PRELIMINARY UNION ELECTRIC COMPANY
PEAK DEMAND PROJECTION

A REPORT TO THE CALLAWAY PROJECT TASK FORCE

PREPARED BY
PETER A. HAIGH

FIGURE A

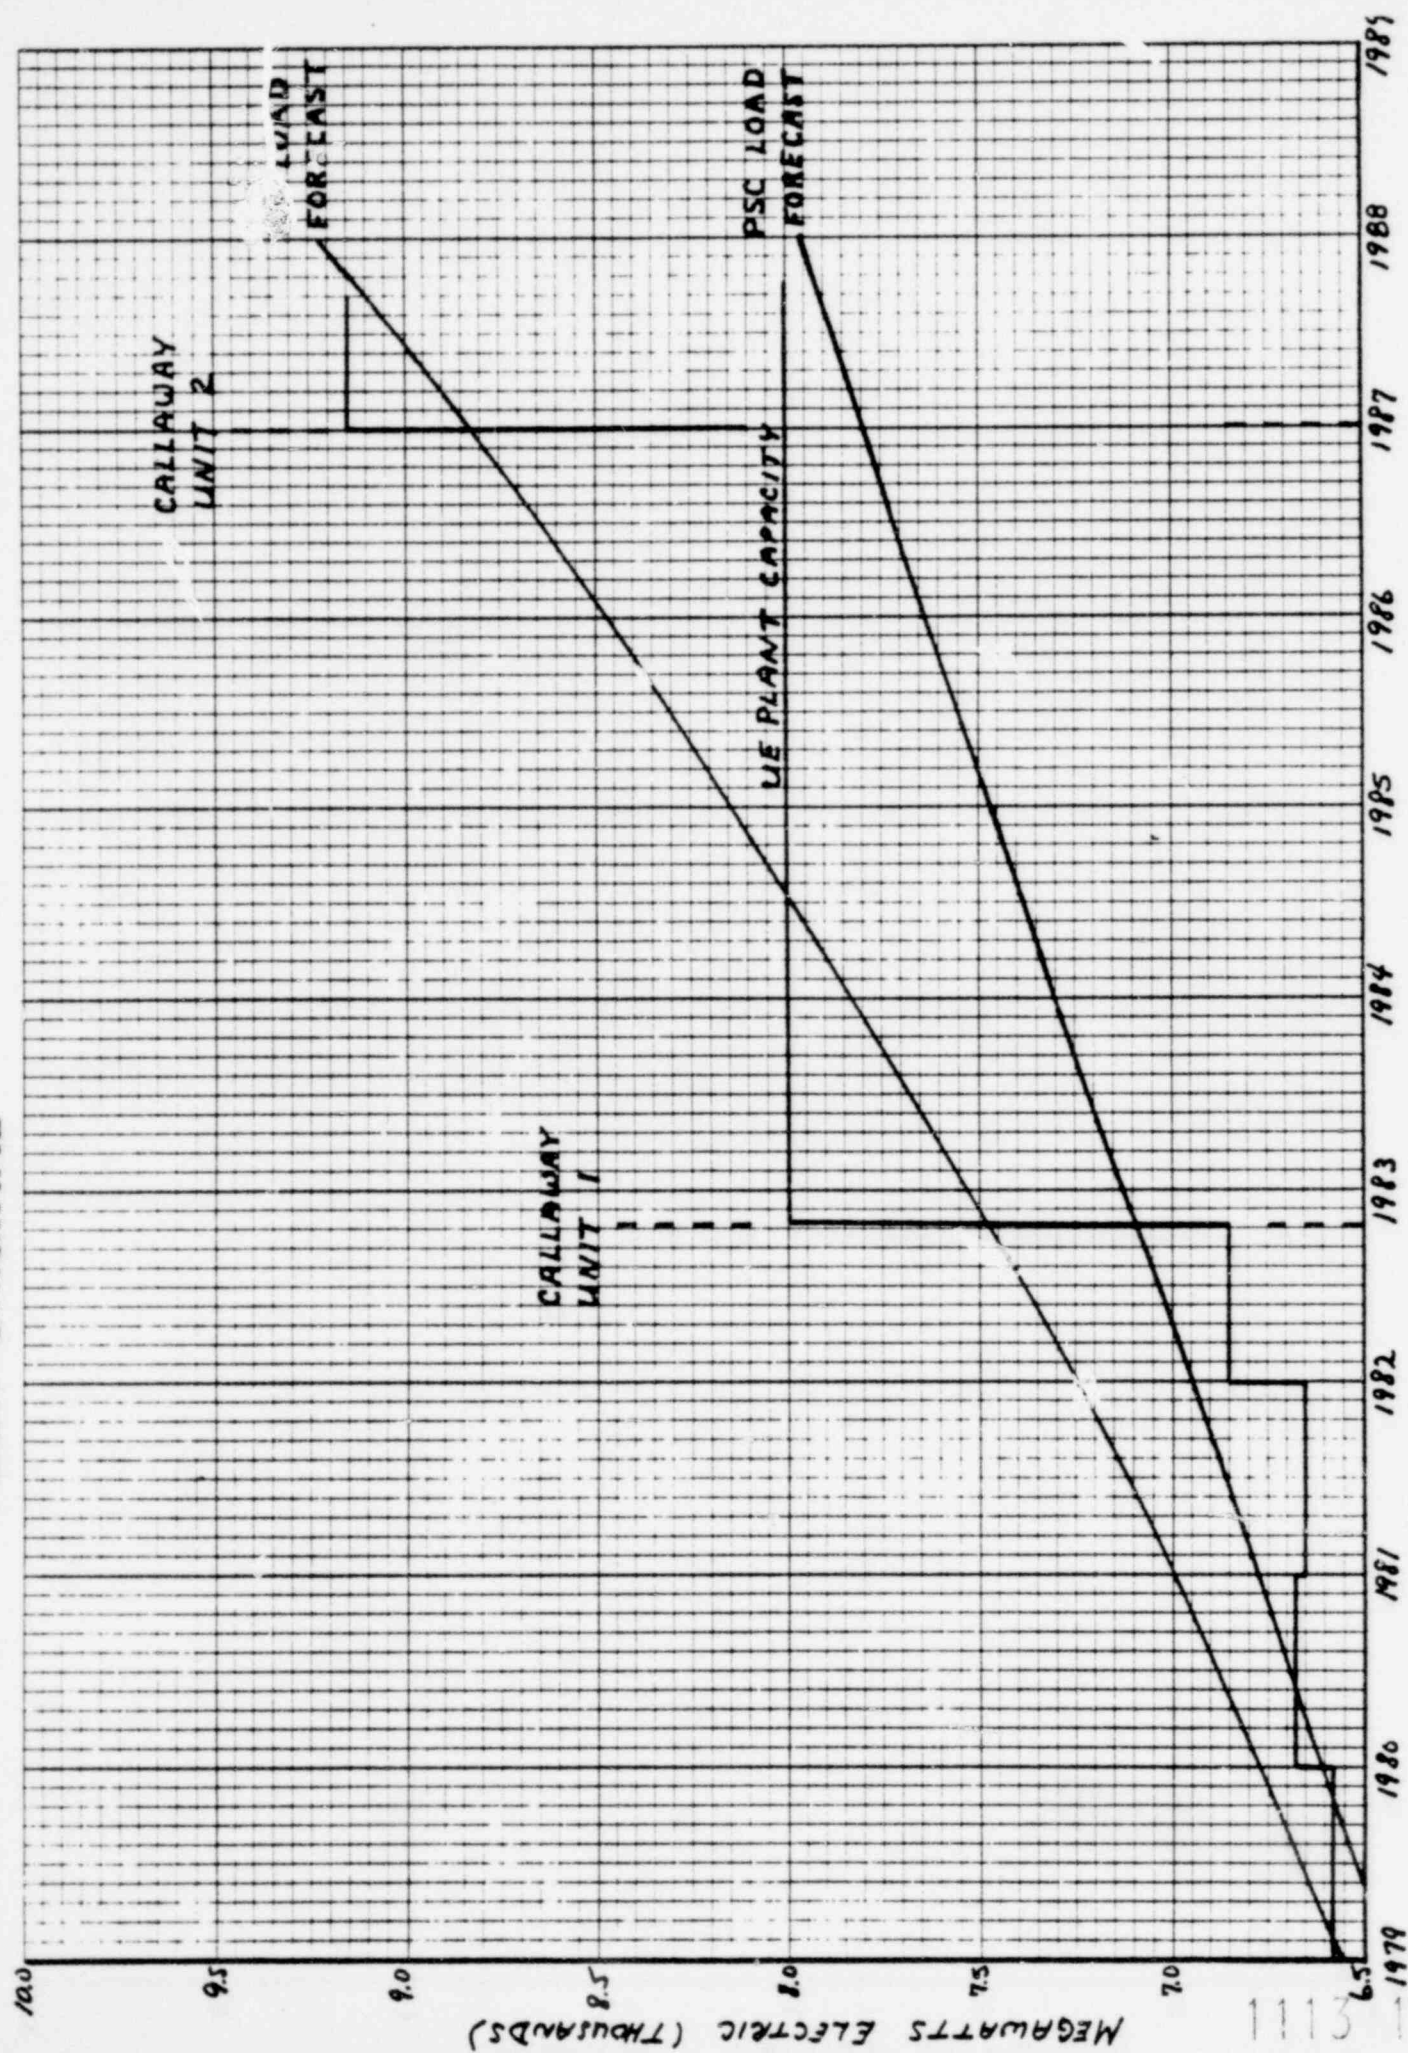
The results of this study are summarized in Figure A following this section. Shown on the graph are the Staff's projection and UE's forecast of the load. As indicated on the Figure for 1987, the Staff model projects a load requirement of approximately 7,800 megawatts while the UE model forecasts approximately 8,830 megawatts.

Also shown on the graph is the planned plant capacity to be installed by UE. In 1982 and 1987 UE plans to add the generating capacity of Callaway Units 1 and 2 respectively. When comparing the available capacity after Callaway Unit 1 is generating power in 1982 with the estimated load requirements as projected by the Staff model, the graphs clearly show that there is excess system capacity available from Unit 1 through 1988.

While Unit 2 is planned for completion in 1987, the graph shows that it is not needed until after 1988. If Unit 2 were finished as UE plans, there will be approximately 1,350 megawatts of excess capacity in 1987 above that which is projected by the Staff model.

FIGURE 1

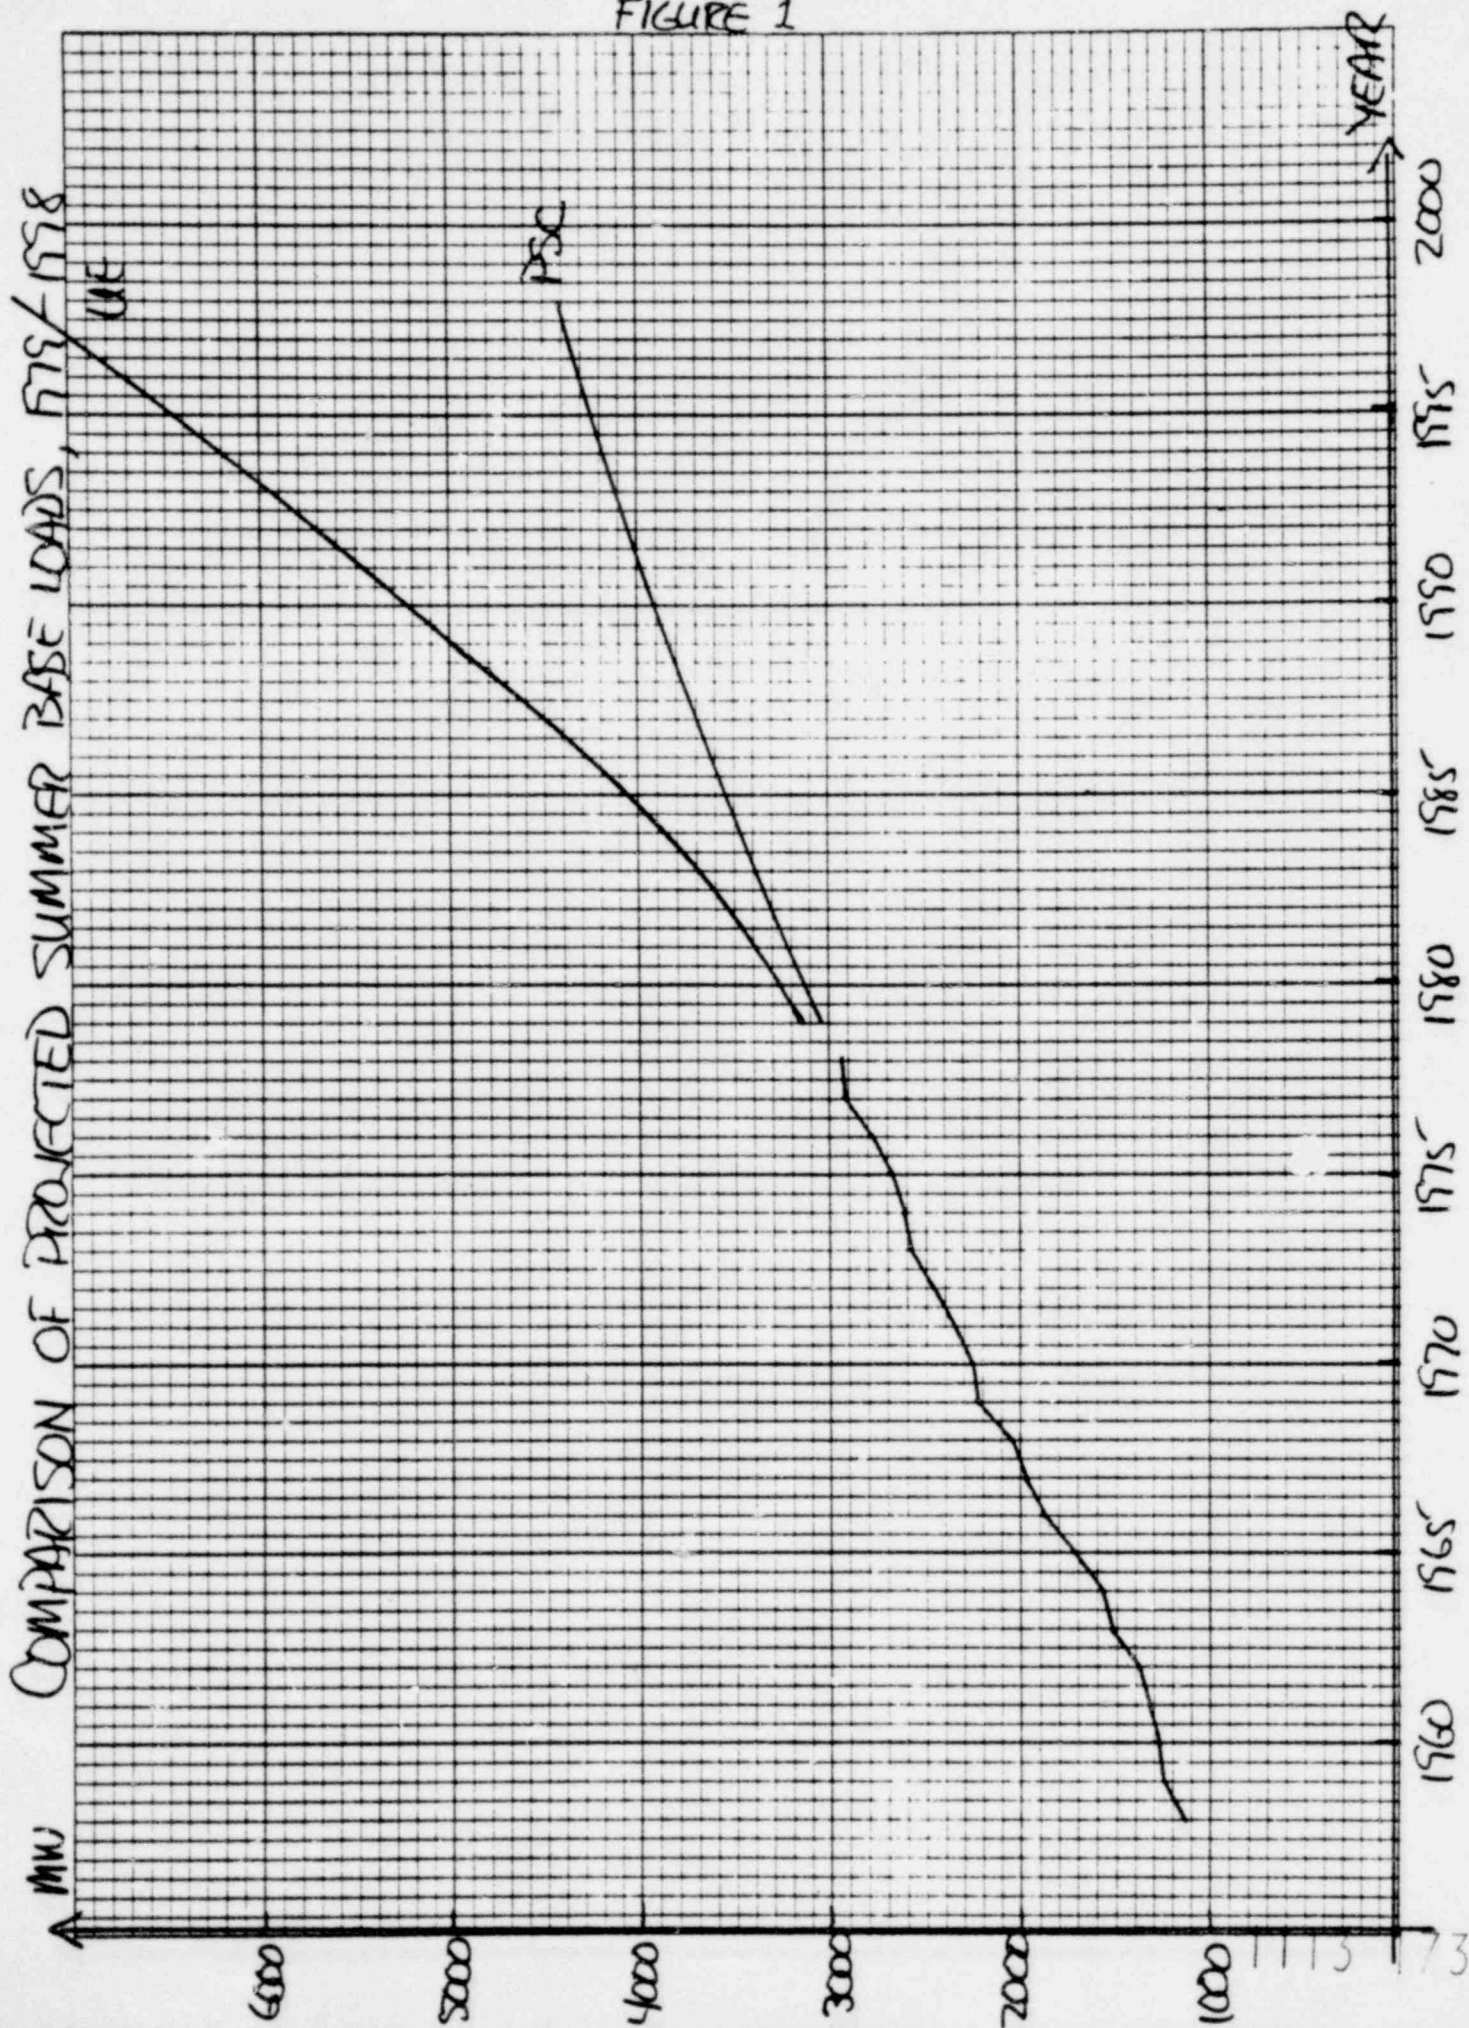
The summer base load projections based on UE's and the Staff's models can be seen graphically in Figure 1 and numerically in Table 1.² The Staff felt discrepancies of this magnitude should

be checked very carefully, especially since both projections are based on models with "good statistics".

FIGURE 2

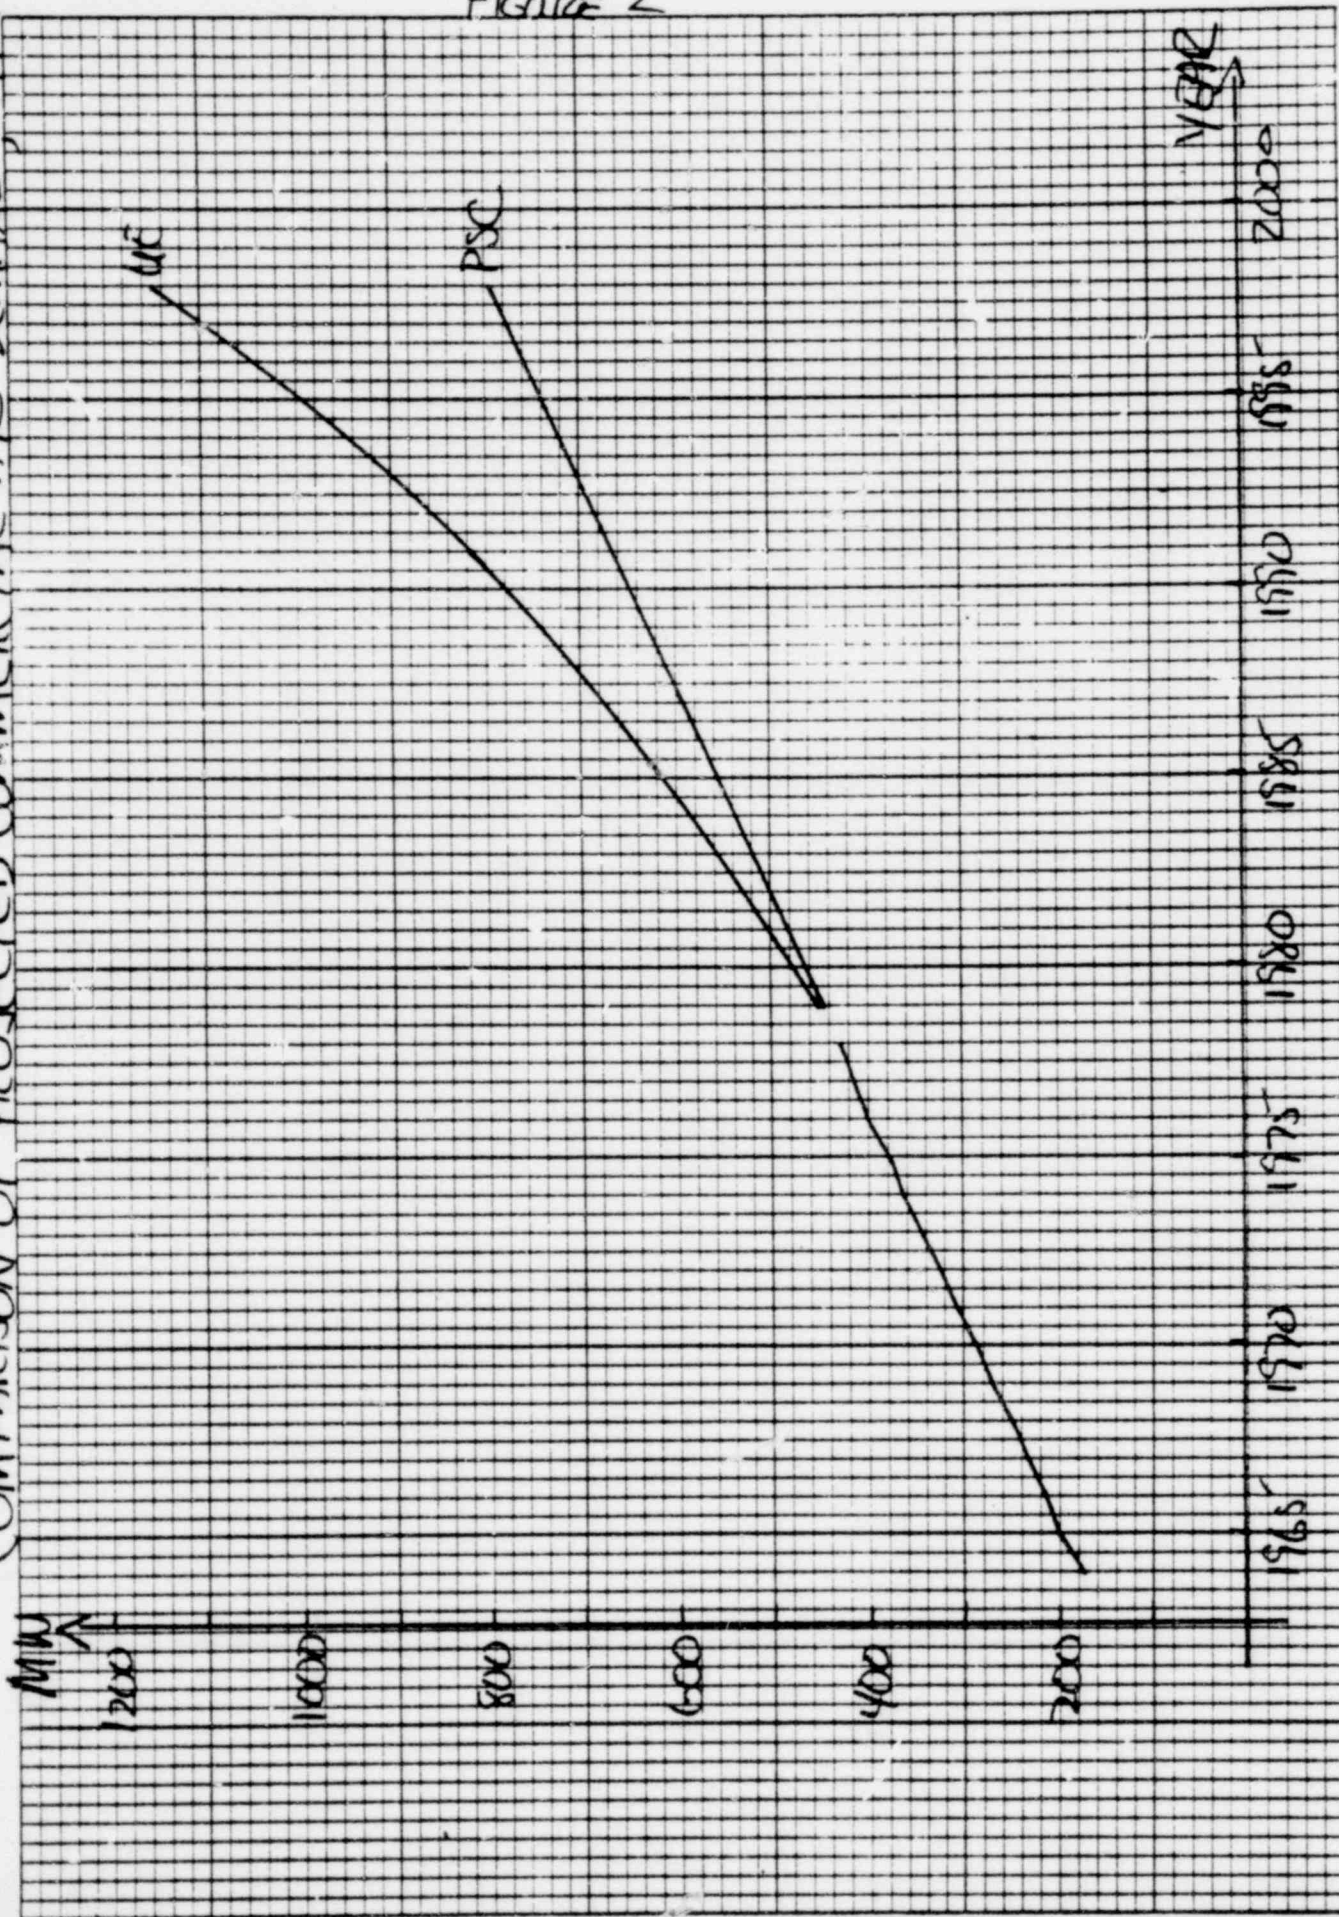
A comparison of the projections made by both models can be found graphically in Figure 2 and numerically in Table 4. Again a relatively large divergence between UE and Staff projections can be seen and, as a result, it was felt desirable to study the accuracy and stability of the two models. Table 5 was developed to compare accuracy and should be read in the same manner as Table 2 while Table 6 shows the sequential commercial A/C demand projections and is similar to Table 3.

Examination of Table 5 shows the Staff model to have a marked tendency to greater accuracy than UE's model and Table 6 shows greater stability in the Staff's sequential forecasts although in neither case is the difference as dramatic as in the case of base load. Looking at Figure 2, the Staff's extension of the historical data series would seem to be a more natural one than that provided

by UE's constant rate of growth. In fact, the actual rate of growth in commercial A/C demand has shown a downward trend since the beginning of the 1970's, see Table 4.
